Addendum No. 03

June 9, 2026

Parlier HS Stadium Replacement

PBK PROJECT NO.: 250093
DSA FILE NO.: 10-H12
DSA APPLICATION NO.: 02-124002 _ PARLIER HS STADIUM REPLACEMENT

PARTIAL SITE PLAN
CS3.3

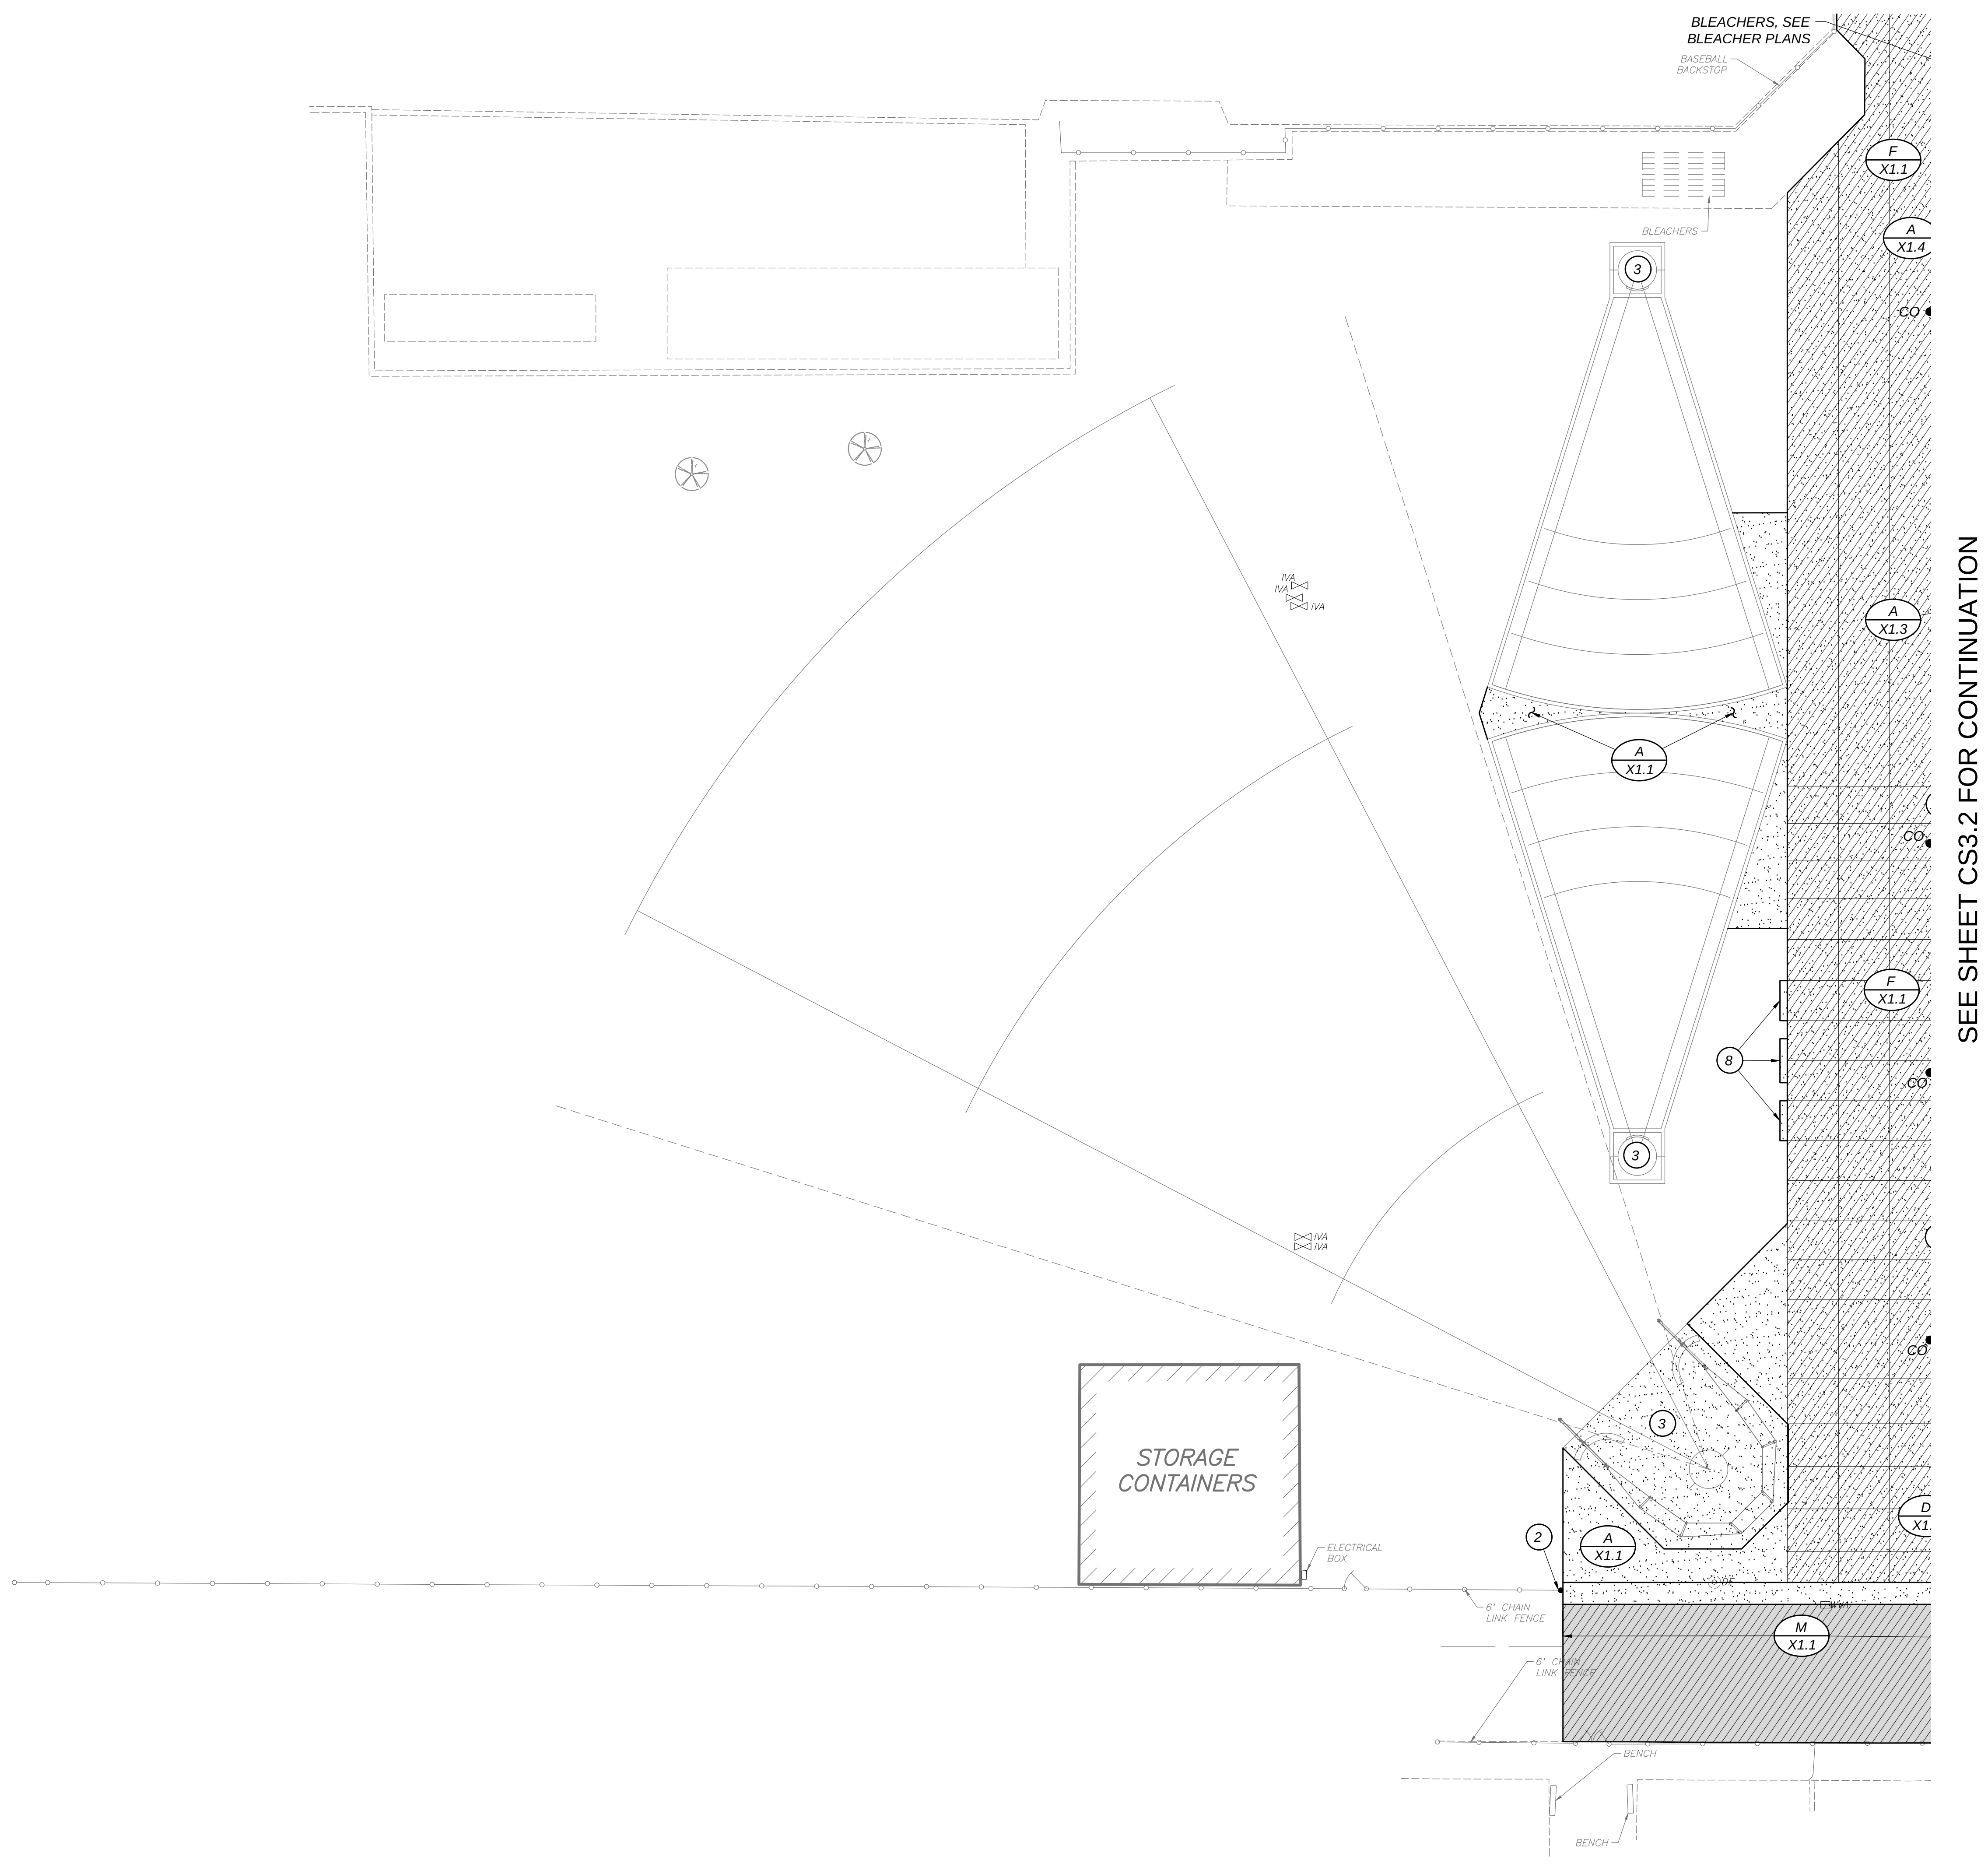
6. Refer to sheet CS3.3 “PARTIAL SITE PLAN”
    a. Remove and replace sheet CS3.3 “PARTIAL SITE PLAN” with herein attached sheet CS3.3 “PARTIAL SITE PLAN” identified with AD3 on the bottom right-hand corner.

- Revised legend and callouts.
- Added Alternative Deduction 6
- Added double gate, striping, and concrete.

PARTIAL HORIZONTAL CONTROL PLAN
CS4.2

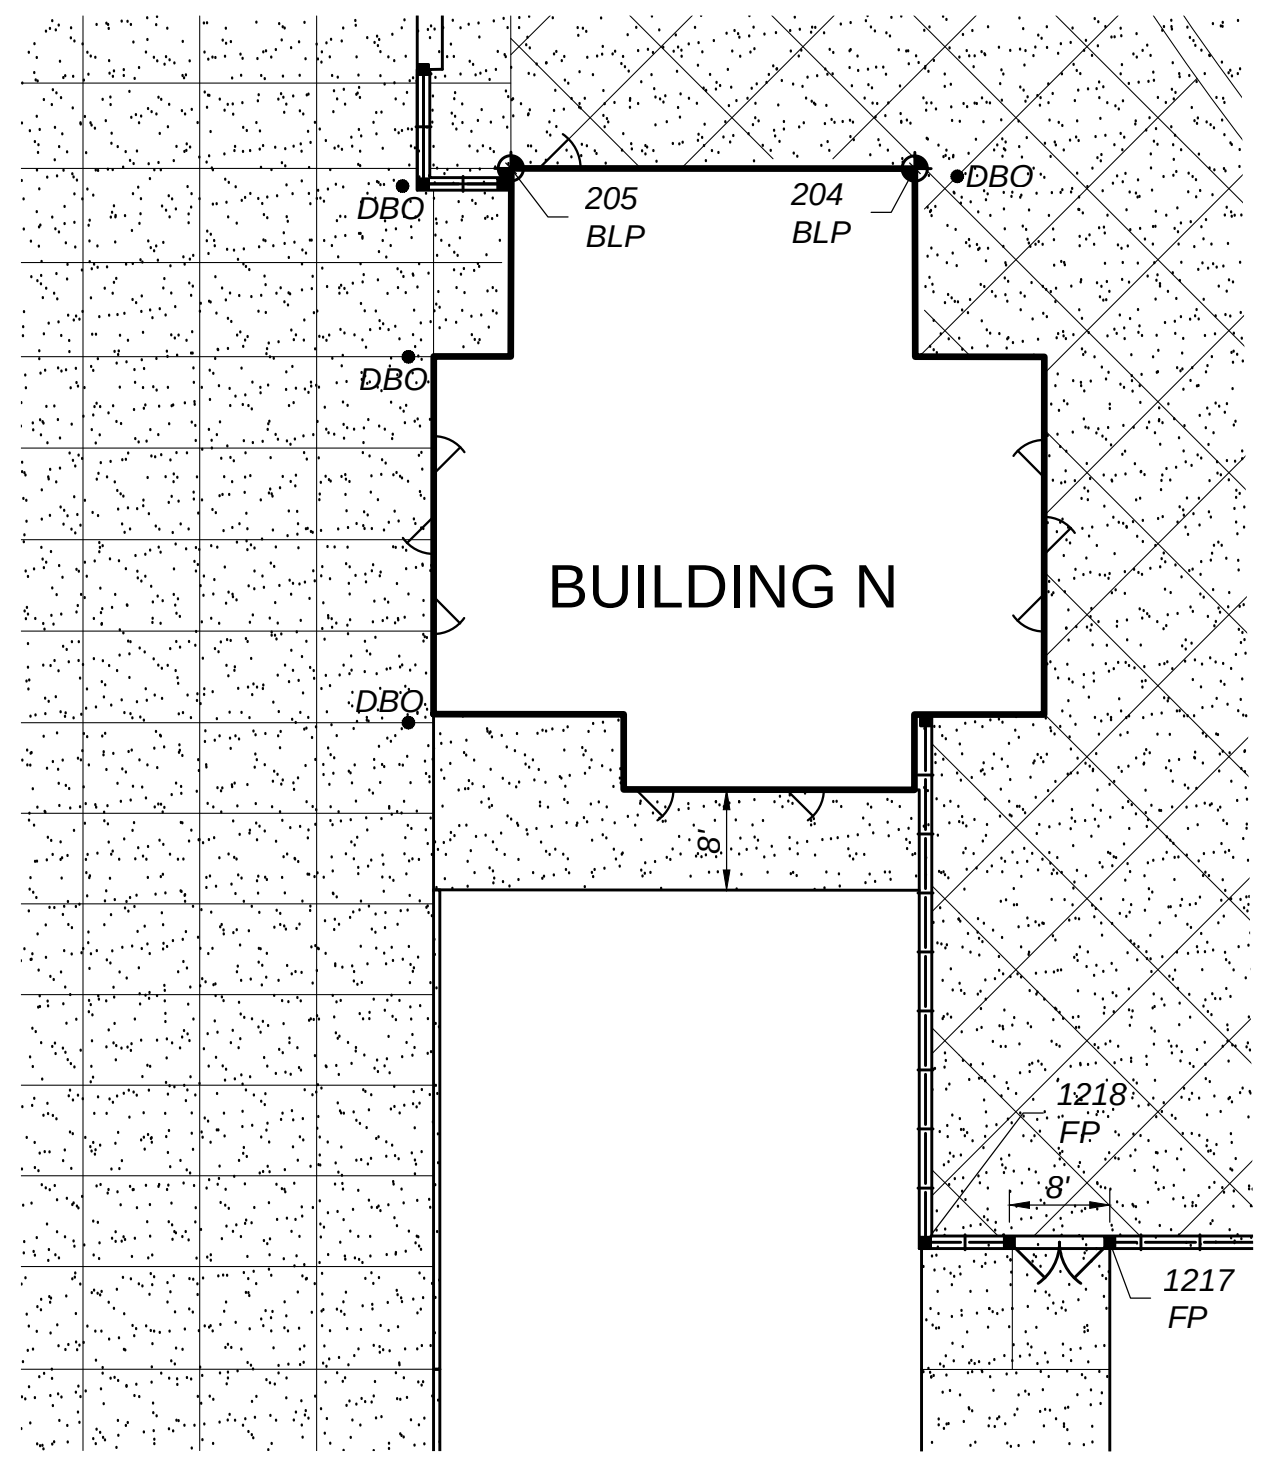
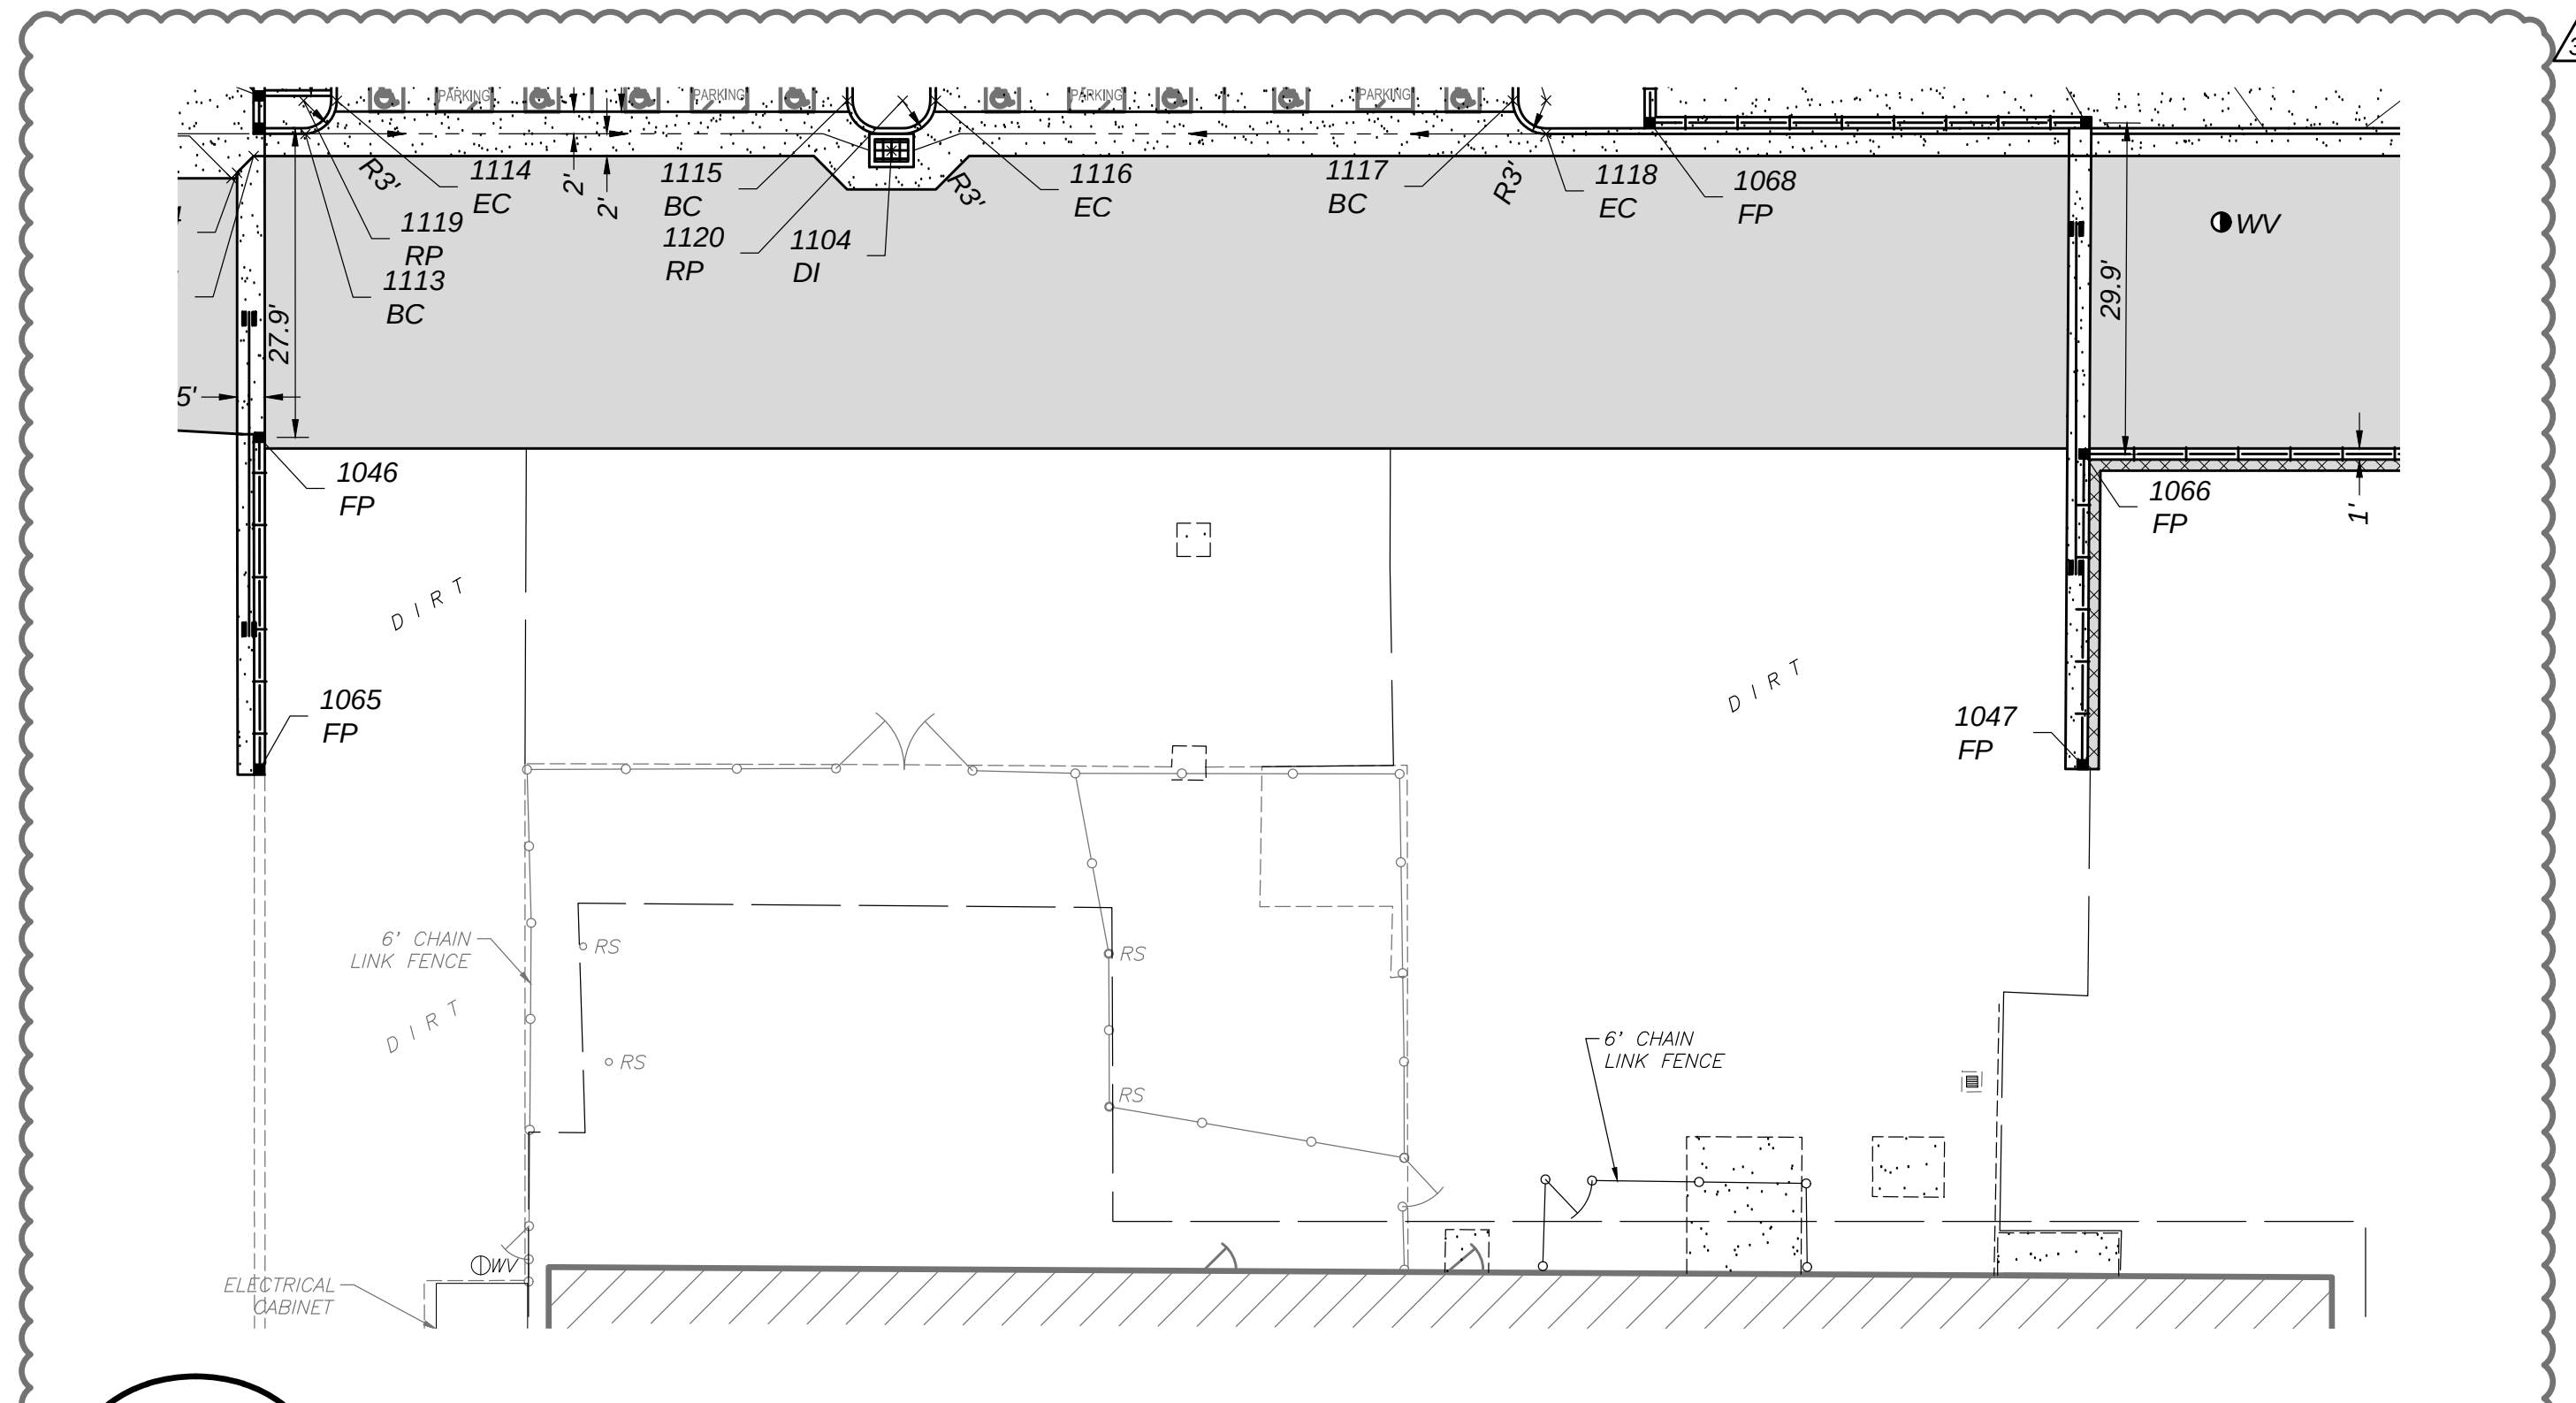
7. Refer to sheet CS4.2 “PARTIAL HORIZONTAL CONTROL PLAN”
    a. Remove and replace sheet CS4.2 “PARTIAL HORIZONTAL CONTROL PLAN” with herein attached sheet CS4.2 “PARTIAL HORIZONTAL CONTROL PLAN” identified with AD3 on the bottom right-hand corner.

- Added horizontal control points and Alternative Deduction 6.
